Re: Recall Campaign No. 92V-071 -
Fuel Injection Lines
Ferrari 348 and Mondial T models

**VEHICLE SAFETY DEFECT
INITIAL INFORMATION REPORT**

**348 ts/tb & Mondial t - Fuel injection lines
Recall No. 147**

RECALL CAMPAIGN NO. 147

Fig.#1

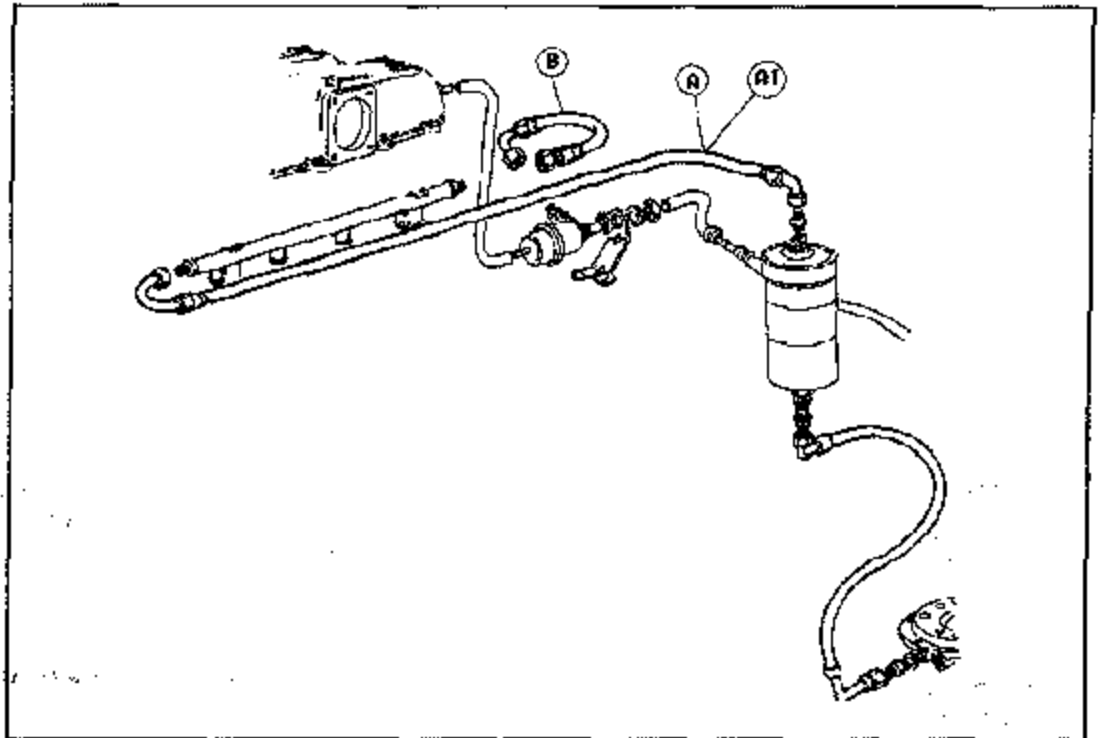
- CONDITION:** The aluminum fuel line fittings on certain fuel Injection lines can corrode under extreme environmental conditions. Should such condition remain unnoticed, the result could be breakage of the aluminum fuel line fitting resulting in fuel leakage.

- REMEDY:** Replacement of the Fuel injection system lines "A & B" with the modified fuel lines (shown on Fig 1, page 6).
- PARTS:** Quantities required for each vehicle and identification of the new Fuel lines with the new part numbers, are shown on the Parts List Table "A" on Page 8). The new part fittings are now aluminum with a non-corrosive coating.

- 5) Remove both fuel lines "A & B" as shown in Fig.# 1 and replace with new lines.
- 6) Inspect 1/4 bank Fuel Injection return line for any damage due to contact with the timing cover. If damage is found the line must be replaced using the procedure "C - Procedure for replacement of fuel return line" found on page # 7 of this booklet. If no damage is found, please insure that the return line is secured on the clip found on the timing cover (Fig.#3). Also the Return Fuel line must not contact the Timing cover or A/C Compressor lines.

Fig.#1a

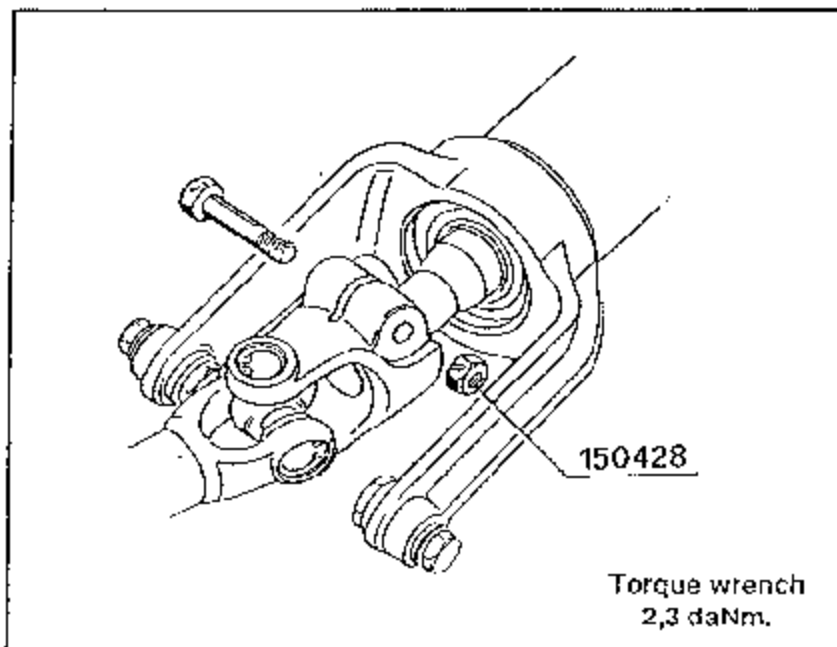
CONDITION: *The upper steering column locknut was manufactured with a lower class of material and self-locking properties. This may result in a loss of tightening torque on the upper steering column fastener. Should such condition remain unnoticed and the use of the car be prolonged for an extensive period of time, loosening of the fastener could occur resulting in play in the steering system and consequential impairment of handling.*

REMEDY: Replacement of the Upper steering column locknut with the improved self-locking nut (shown on Fig 1, page 11).

- A. Preliminary: The replacement self-locking nut (Fig.#1a) is supplied as a spare part (PN# 150428) by the Ferrari North America parts department.
- B. Procedure for installation
- 1) Cover interior (seat and carpeting).
 - 2) Remove 13mm locknut from upper steering column fastener and replace with new 13mm self locking nut (PN# 150428) as shown in fig.# 1 below.
 - 3) Check that the steering column shaft is properly inserted into the steering column extension. Fastener must go through the groove provided in the steering column shaft.
 - 4) Torque self-locking nut to 2.3 daNm (17 lbs/ft).
 - 5) Check for binding in steering system. If there is binding, check system for faults.
 - 6) Remove all protective covers from interior and insure that the area is clean.

Fig.#1b

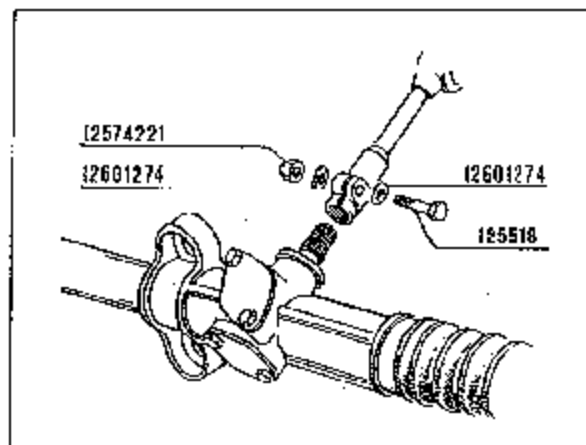
CONDITION: On 348 ts/tb vehicles with Vehicle Identification Number lower than 86212, the *steering box extension fastener* was manufactured with a lower class of material and self-locking properties. This may result in a loss of tightening torque on the upper steering column fastener. Should such condition remain unnoticed and the use of the car be prolonged for an extensive period of time, loosening of the fastener could occur resulting in play in the steering system and consequential impairment of handling.

REMEDY: Replacement of the Steering box extension fastener with the improved fastener (shown on Fig 1, page 13).

- 1) Cover interior (seat and carpeting).
- 2) Move carpeting away from area of steering extension located under the dash at the base of the front cabin wall.
- 3) Remove 10mm locknut from steering extension fastener and remove the fastener.
- 4) Check that the steering box shaft is properly inserted into the steering column extension. Fastener must go through the groove provided in the steering box shaft.
- 5) Install new fastening bolt along with the two washers and locknut as shown in fig.# 1 below.
- 6) Torque Fastener nut to 1.2 daNm (9 lbs/ft).
- 7) Replace carpeting around area of steering extension.
- 8) Check for binding in steering system. If there is binding, check system for faults.
- 9) Remove all protective covers from interior and insure that the area is clean.

Fig.#1a

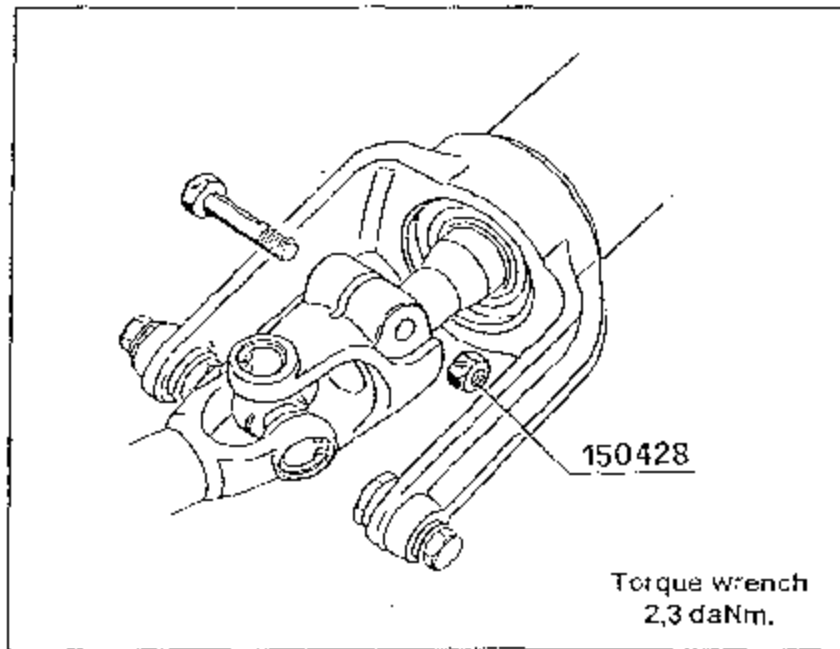
INSTRUCTIONS FOR LOCKNUT REPLACEMENT

- A. Preliminary: The replacement self-locking nut (Fig.#1a) is supplied as a spare part (PN# 150428) by the Ferrari North America parts department.
- B. Procedure for installation
- 1) Cover interior (seat and carpeting).
 - 2) Remove 13mm locknut from upper steering column fastener and replace with new 13mm self locking nut (PN# 150428) as shown in fig.# 1 below.
 - 3) Check that the steering column shaft is properly inserted into the steering column extension. Fastener must go through the groove provided in the steering column shaft.
 - 4) Torque self-locking nut to 2.3 daNm (17 lbs/ft).
 - 5) Check for binding in steering system. If there is binding, check system for faults.
 - 6) Remove all protective covers from interior and insure that the area is clean.

Fig.#1b

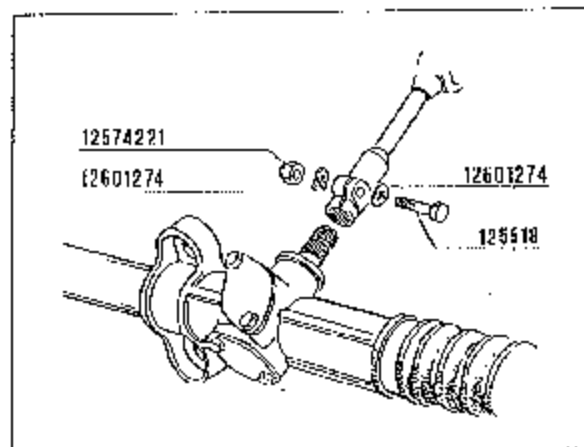
- 3) Remove 10mm locknut from steering extension fastener and remove the fastener.
 - 4) Check that the steering box shaft is properly inserted into the steering column extension. Fastener must go through the groove provided in the steering box shaft.

- 5) Install new fastening bolt along with the two washers and locknut as shown in fig.# 1 below.
 - 6) Torque Fastener nut to 1.2 daNm (9 lbs/ft).
 - 7) Replace carpeting around area of steering extension.

Fig.#1

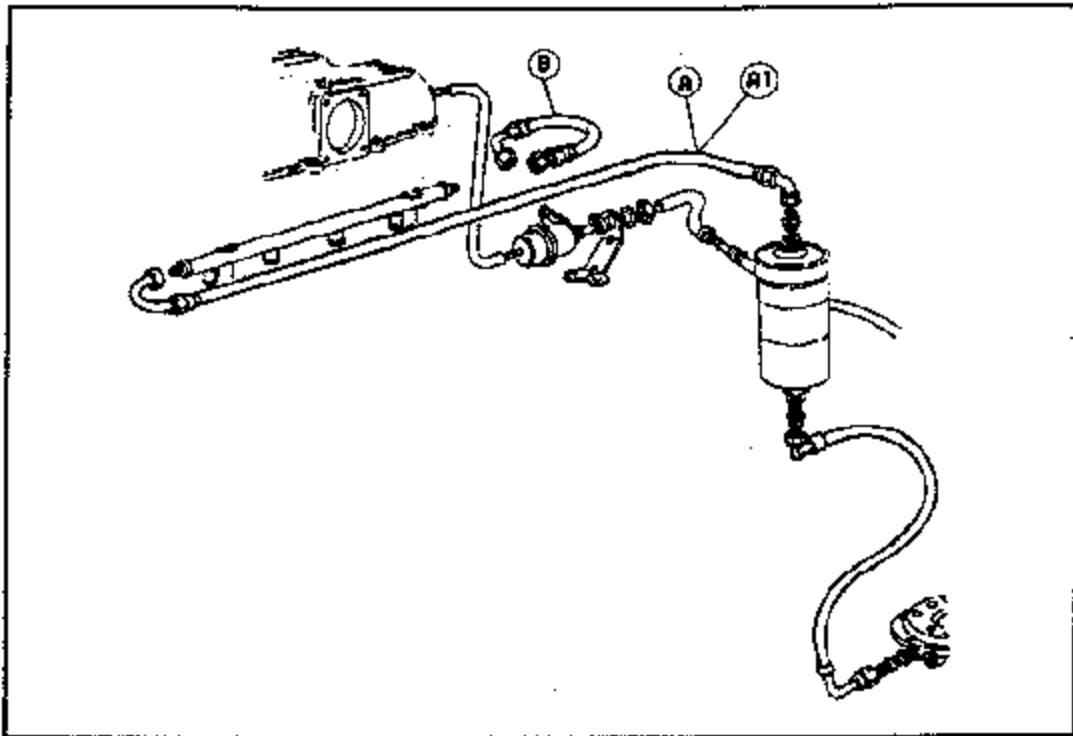
- REMEDY:** Replacement of the Fuel injection system lines "A & B" with the modified fuel lines (shown on Fig 1, page 6).
- PARTS:** Quantities required for each vehicle and identification of the new Fuel lines with the new part numbers, are shown on the Parts List Table "A" on Page 8). The new part fittings are now aluminum with a non-corrosive coating.

- 5) Remove both fuel lines "A & B" as shown in Fig.# 1 and replace with new lines.
- 6) Inspect 1/4 bank Fuel Injection return line for any damage due to contact with the timing cover. If damage is found the line must be replaced using the procedure "C - Procedure for replacement of fuel return line" found on page # 7 of this booklet. If no damage is found, please insure that the return line is secured on the clip found on the timing cover (Fig.#3). Also the Return Fuel line **must not** contact the Timing cover or A/C Compressor lines.

Fig.#1a

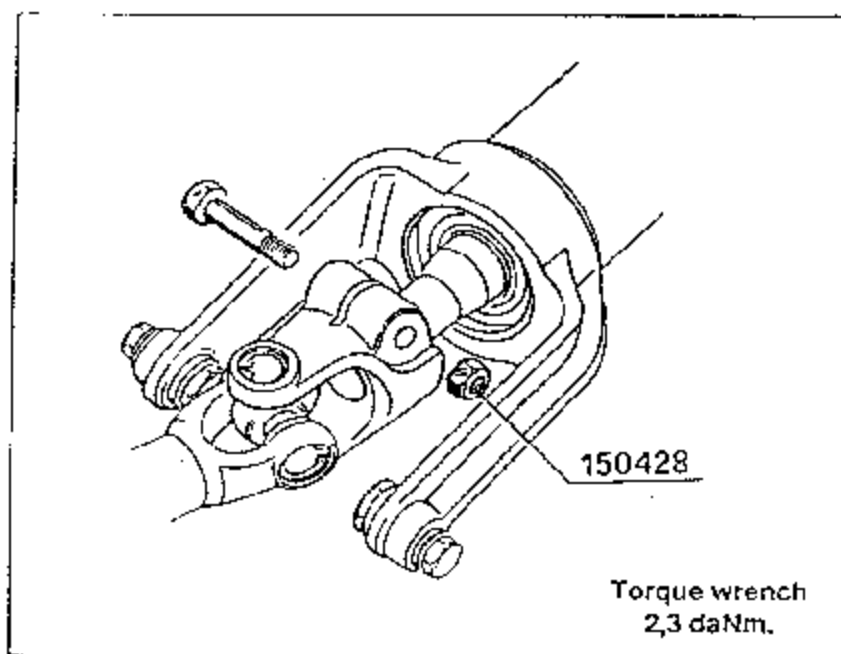
INSTRUCTIONS FOR LOCKNUT REPLACEMENT

- A. Preliminary: The replacement self-locking nut (Fig.#1a) is supplied as a spare part (PN# 150428) by the Ferrari North America parts department.
- B. Procedure for installation
- 1) Cover interior (seat and carpeting).
 - 2) Remove 13mm locknut from upper steering column fastener and replace with new 13mm self locking nut (PN# 150428) as shown in fig.# 1 below.
 - 3) Check that the steering column shaft is properly inserted into the steering column extension. Fastener must go through the groove provided in the steering column shaft.
 - 4) Torque self-locking nut to 2.3 daNm (17 lbs/ft).
 - 5) Check for binding in steering system. If there is binding, check system for faults.
 - 6) Remove all covers from interior and insure that the area is clean.

Fig.#1b

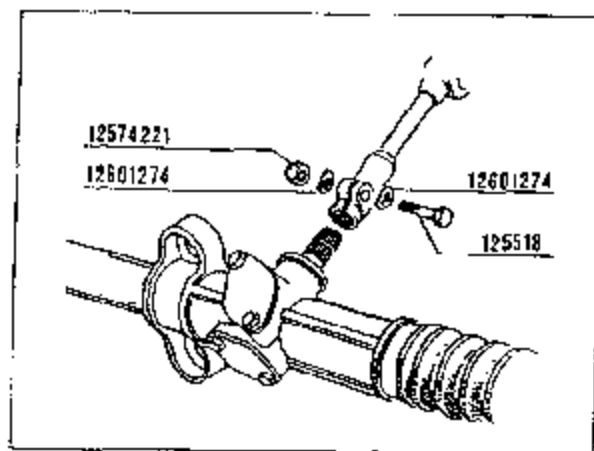
- 3) Remove 10mm locknut from steering extension fastener and remove the fastener.
 - 4) Check that the steering box shaft is properly inserted into the steering column extension. Fastener must go through the groove provided in the steering box shaft.

- 5) Install new fastening bolt along with the two washers and locknut as shown in fig. # 1 below.
 - 6) Torque Fastener nut to 1.2 daNm (9 lbs/ft).
 - 7) Replace carpeting around area of steering extension.
